Project	IEEE 802.16 Broadband Wireless Access Working Group < http://iee802.org/16 >	
Title	ARQ Changes for 802.16abc-01/01r1	
Date Submitted	2001-08-26	
Source(s)	Vladimir Yanover Alvarion Ltd. 21 A Habarzel St. Ramat - Hahayal Tel - Aviv 69710 P.O. Box 13139, Tel-Aviv 61131, Israel	Voice: +972-36457834 Fax: +972-36456222 mailto:vladimiry@breezecom.co.il
Re:	Update for the ARQ text initially published in 802.16abc-01/01	
Abstract	This document contains fragments of text and pictures intended to fix the comments resolution at the IEEE 802.16 Session #14	
Purpose	This document is contributed to describe details of certain comment submitted in response to th Call for Comments IEEE 802.16ab-01/06r1	
Notice	This document has been prepared to assist IEEE 802.16. It is offered as a basis for discussion and is not binding on the contributing individual(s) or organization(s). The material in this document is subject to change in form and content after further study. The contributor(s) reserve(s) the right to add, amend or withdraw material contained herein.

ARQ Changes for 802.16abc-01/01r1

This document contains fragments of text and pictures intended to fix the comments resolution at t

Figure 1. Options for the MSDU transmission

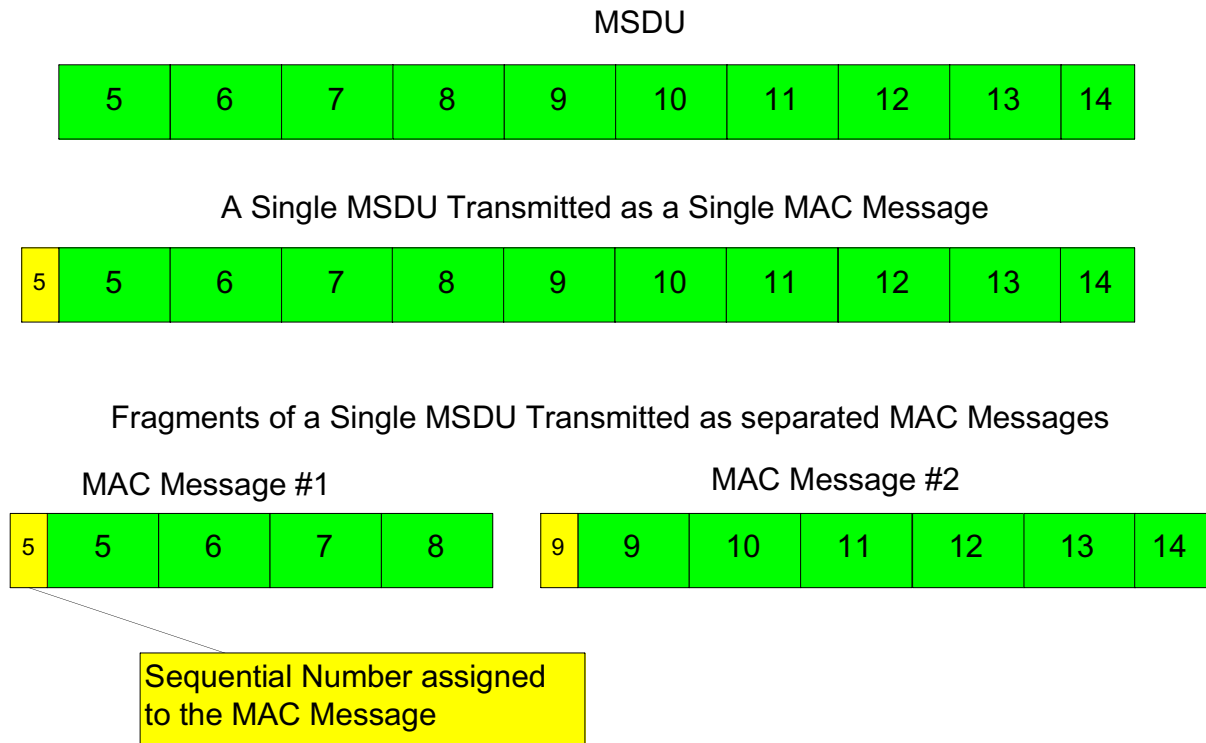
The following pictures will replace the correspondent figures from 6.3.2 (01/01 document)
